Clarification of 802.1CB Clauses 6.6 and 9.1.4 Active Destination MAC and VLAN stream identification function

IEEE 802.1 Interim Salt Lake City

May, 2019

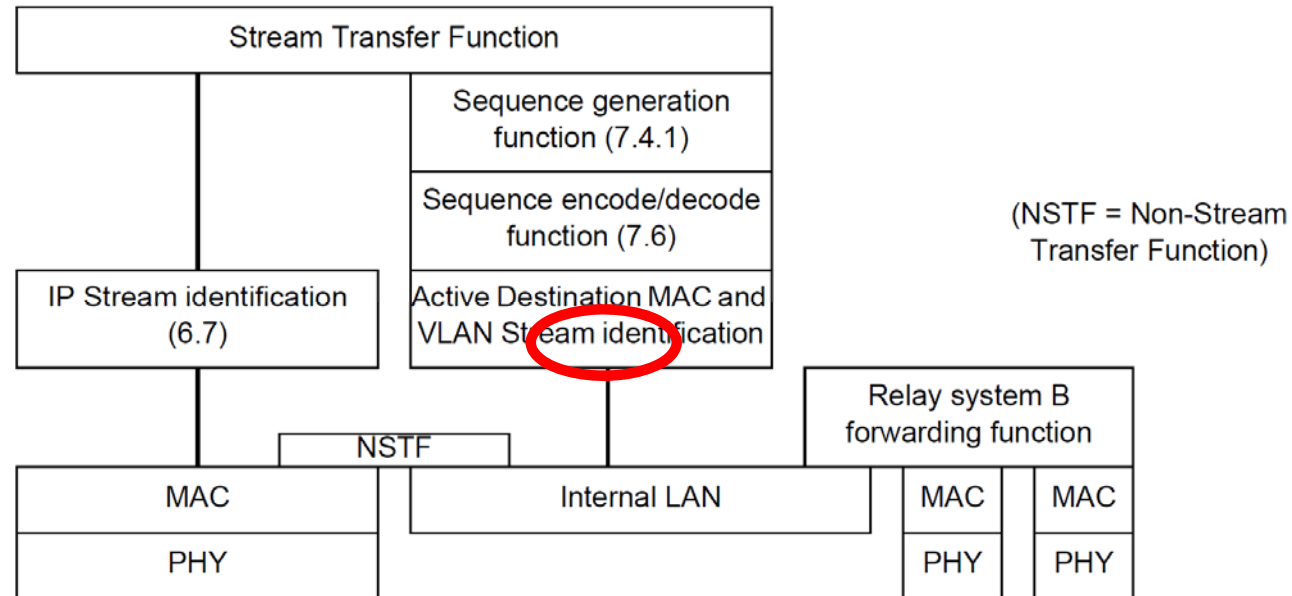
- And... there is a missing cross-reference to the Active Destination MAC and VLAN Stream identification function in figure C-5:

- Figure C-5

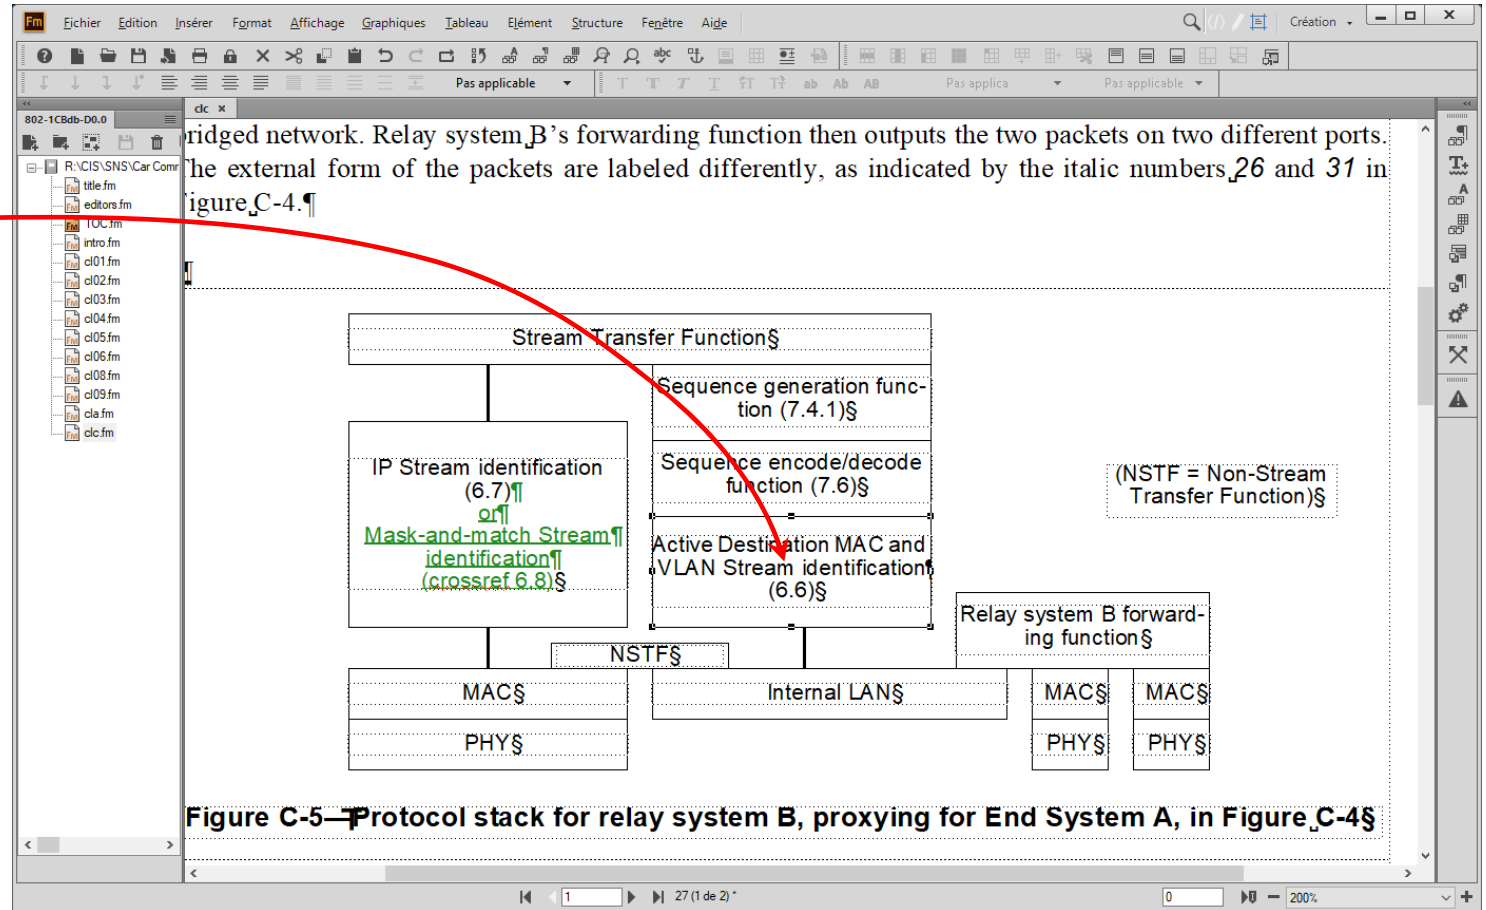
- the reference to 6.6 was there !

- just hidden after a mischievous resize of the box
